Metropolitan Development Commission Regional Center Hearing Examiner (August 13, 2026) Meeting Agenda

REGIONAL CENTER HEARING EXAMINER - HIGH IMPACT CASE

Case Number	2026-REG-041
Address (approx.)	951 S White River Parkway, West Drive
Location	Center Township, Council District #18
Petitioner	Justin Kingen
Zoning	C-S (RC)
Request	Regional Center Approval to provide for construction of a surface parking lot that is over 20,000 square feet.

The petitioner requests Regional Center approval for a paved surface parking lot at 951 South White River Parkway, West Drive. The site was rezoned to C-S under petition 2026-ZON-003 to provide overflow parking for the Biltwell Event Center across the street (950 South West River Parkway, West Drive). The proposed lot includes 79 paved and striped spaces, perimeter and interior landscaping, and two directional pylon signs.

Site Plan

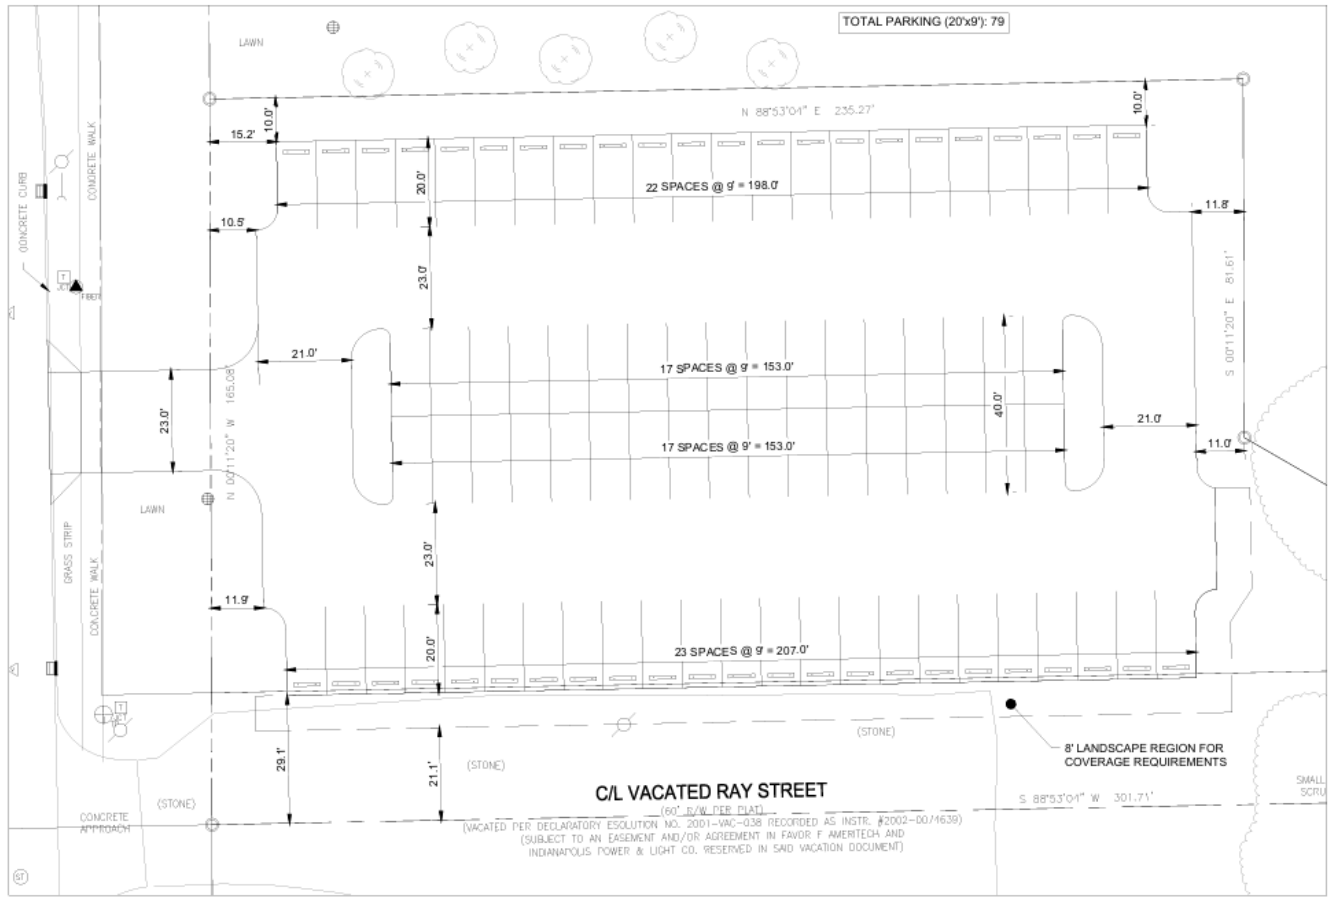
1. The Comprehensive Plan recommendation is City Neighborhood. A surface parking lot would not comply with this recommendation. The rezoning of the site, to C-S, provides that a surface parking lot is a permitted use on the site. There are no commitments relative to the minimum number of parking spaces provided. Therefore, additional measures shall be required to enhance the proposed use. Guidelines US 1.1.1 and SC 1.1.1 apply. Therefore, this parking lot shall be no larger than 20,000 square feet and additional landscaping shall be required, including larger tree islands.

2. The Regional Center typology for this site is City Neighborhood. City Neighborhood discourages surface parking lots with over 20 parking spaces. Proposed parking lots should be subordinate to the primary use of the site. This parking lot would be the primary use. Therefore, additional measures shall be required to enhance the proposed use. Guidelines SC 3.1.1. and SC 3.2.1 apply. Therefore, this parking lot shall be no larger than 20,000 square feet and additional landscaping shall be required, including larger tree islands.

3. The petition submittal did not include a development statement. Therefore, details of the construction of the parking lot are unknown. Guideline SC 3.2.6 provides that bio-swales shall be provided. Bio-swales can increase greenspace and significantly reduce water run-off to the nearby White River. This area is also prone to flooding. This development, with adequate engineering, could improve flooding issues.

4. The trees and shrubs proposed are inadequate. The petitioner shall work with City staff for input on appropriate tree and shrub species and submit a revised landscape plan for staff review and approval. Guideline 4.6.4 applies.

5. A lighting plan was not submitted to the file to identify the location of lighting standards. Additionally, a photometric plan has not been submitted to the file. A photometric plan should detail light standards and photometric levels for the site and at each entrance. Lighting must be provided at each entrance and must be dusk to dawn. Only full cut and shielded light standards are permitted with minimum foot-candle power outlined in CA 4.3.2 and CA 4.3.3. Pedestrian areas and entries must be lighted for safety (CA 3.1.3 and CA 4.3.1). A lighting and photometric plan shall be submitted and subject to planning staff review and approval, prior to the issuance of an Improvement Location Permit.

6. A marked pedestrian crosswalk shall be provided between the parking lot and the Biltwell to ensure safe pedestrian access. Guideline SC 3.2.2 applies.

7. A pedestrian walkway shall be provided to connect the existing public sidewalk to the parking lot to provide a safe and accessible pedestrian route. Guideline SC 3.2.4 applies.
8. A marked pedestrian crosswalk shall be provided within the parking lot to connect the walkway to the landscaped island. Guideline SC 3.2.2 applies.
9. The proposed aisle width shall be revised to comply with the zoning ordinance, which requires a minimum aisle width of 23 feet.

Staff **recommends approval** of the Regional Center Approval petition subject to the following conditions:

The above Summary items must be met.
